Re: A request by Dexter Acres L.C. for approval of the Final Plat of Dexter Acres 7th Addition, a proposed 34 lot residential subdivision located adjacent to Dexter Acres 4th, 5th, & 6th Addition, Pacha Farms First Addition and 190th Avenue in part of the NE¼ of Section 31 of Butler Township.

PLANNING & ZONING COMMISSION
STAFF REPORT
April 18, 2017

Request: Final Plat of Dexter Acres 7th Addition

FINAL PLAT OF DEXTER ACRES SEVENTH ADDITION TO SCOTT COUNTY, IOWA

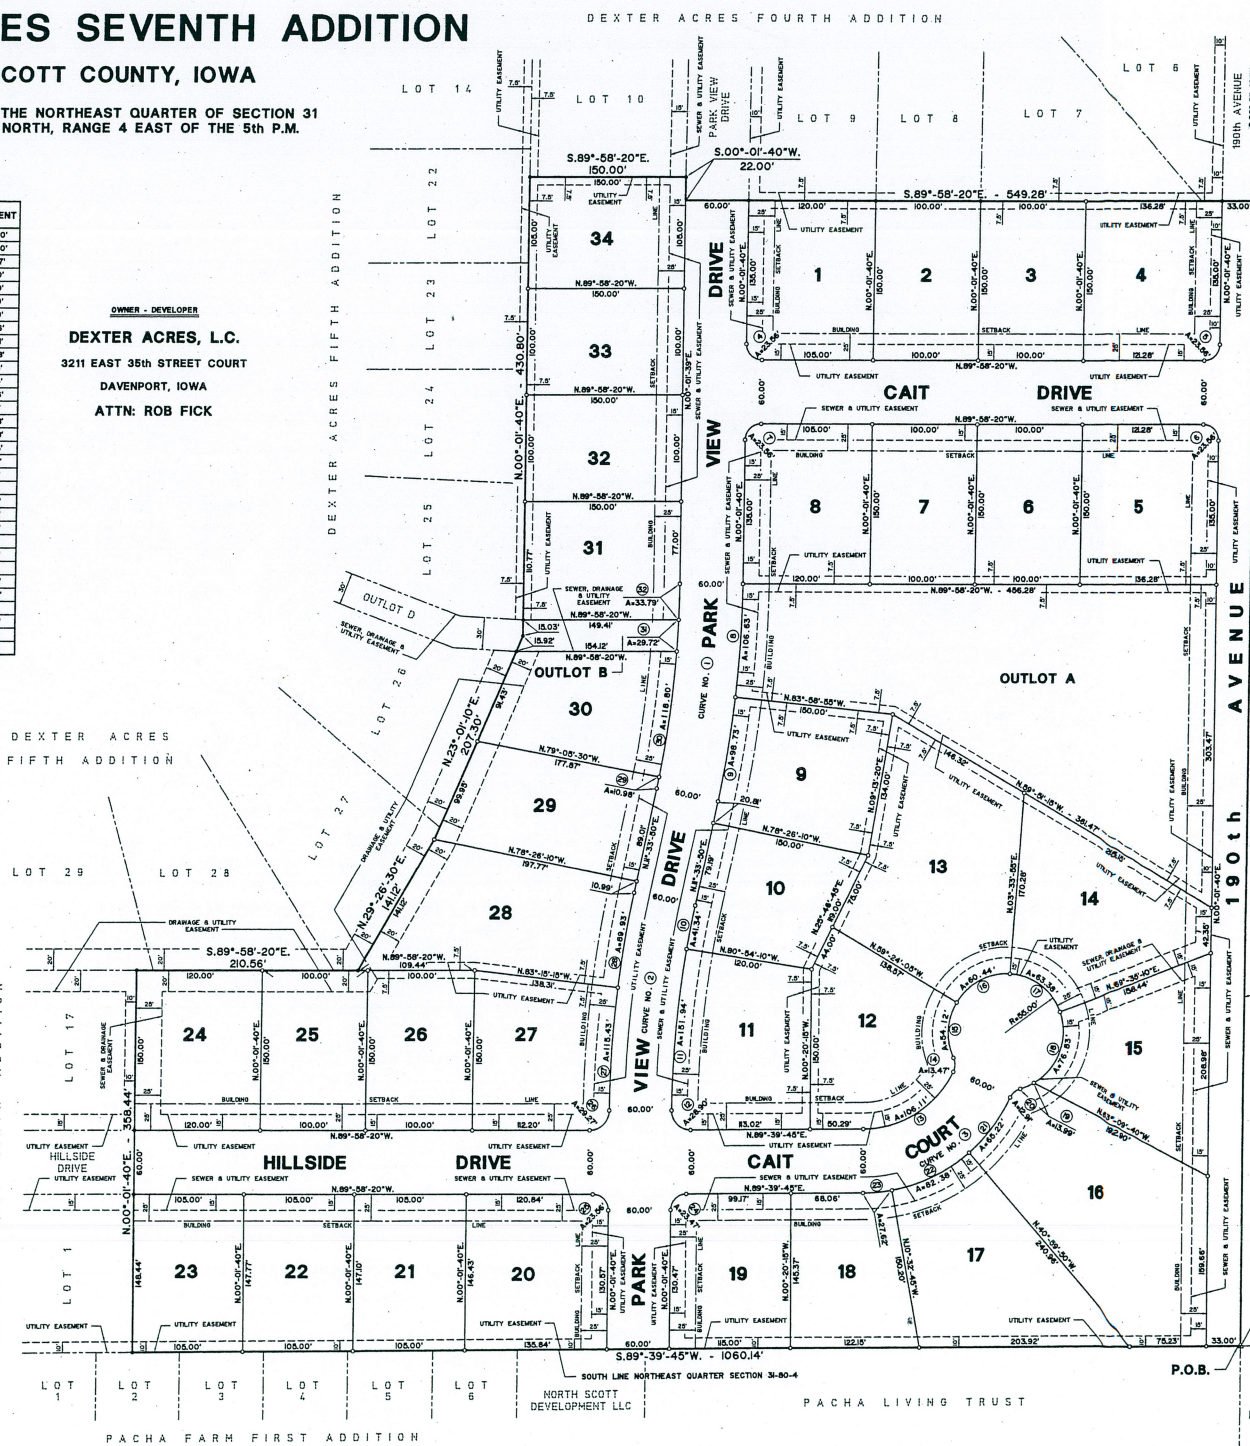
This proposed addition contains twenty (20) acres which complies with the condition of Preliminary Plat approval that no greater than twenty (20) acres be disturbed at any one time. This final plat also includes two outlots: Outlot B, which is a continuation of the Park View interior trail system; and Outlot A, a two-acre open space and Stormwater management basin.

The County Engineer has reviewed and approved the road construction and erosion control plans for the 7th Addition. Road and utility construction can be initiated but are not expected to be completed prior to Final Plat approval. Therefore surety to secure the improvements included in this 7th Addition will have to be submitted prior to Final Plat approval by the Board of Supervisors.

Staff has noted that the proposed names of Cait Drive and Cait Court for two non-contiguous streets is needlessly confusing. Staff has asked that another name be proposed for one of those two streets.

The County Engineer has determined that the erosion control plan complies with the condition set forth at the time the Preliminary Plat for this development was approved. At the time of Preliminary Plat approval the developer and his engineer were advised that the erosion control measures along the entire west boundary of this plat will have to be carefully monitored to ensure they stay in place, especially after heavy rains. The Natural Resources Conservation Service also has been provided a copy of these plans. Staff has not received any comments from the NRCS.

RECOMMENDATION: Staff recommends that the Final Plat of Dexter Acres 7th Addition be approved with the condition that the surety for the road and utility improvements be posted prior to approval by the Board of Supervisors and that the Park View Water Company and the Sanitary District approve the sewer and water system plans.
